Agenda Item: AH21
Source: CWTS/CATT
To: TSG RAN WG1
Title: Coding of transport formats combination indicator (TFCI) for QPSK of 1.28Mcps TDD
Document for: Discussion and Approval

Figure [X1]: Mapping of TFCI word bits to TFCI position in 1.28 Mcps TDD option, where N = N_{TFCI}.

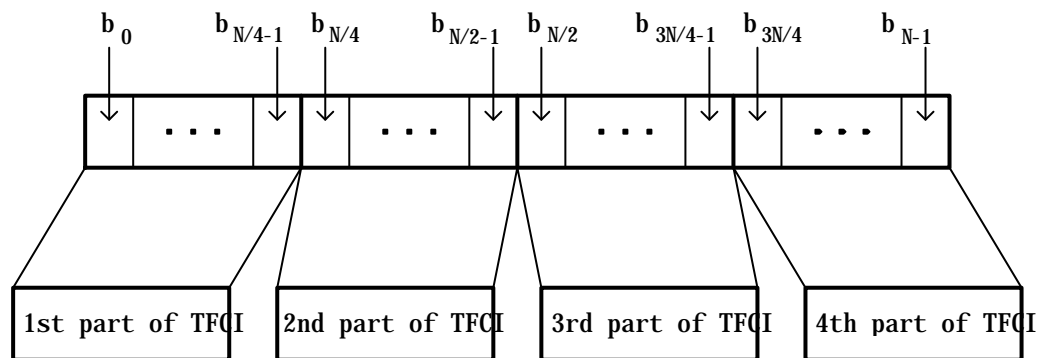
When the number of bits in the TFCI is 8,16,32, the mapping of the TFCI word to the TFCI bit positions shall be as follows.

Figure [X2]: Mapping of TFCI word bits to TFCI position in 1.28 Mcps TDD option, when $N_{TFCI}=4$

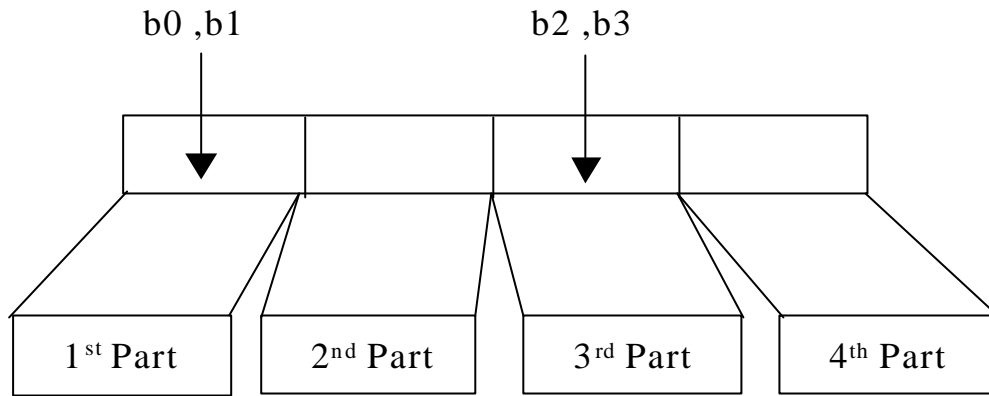
When the number of bits in the TFCI is 4 , the mapping of TFCI word to the TFCI bit position is that the TFCI bits are equally divided into two part for the consecutive two subframe and mapped onto the end of the first data field respectively . The 4 bits mapping is show as follows:
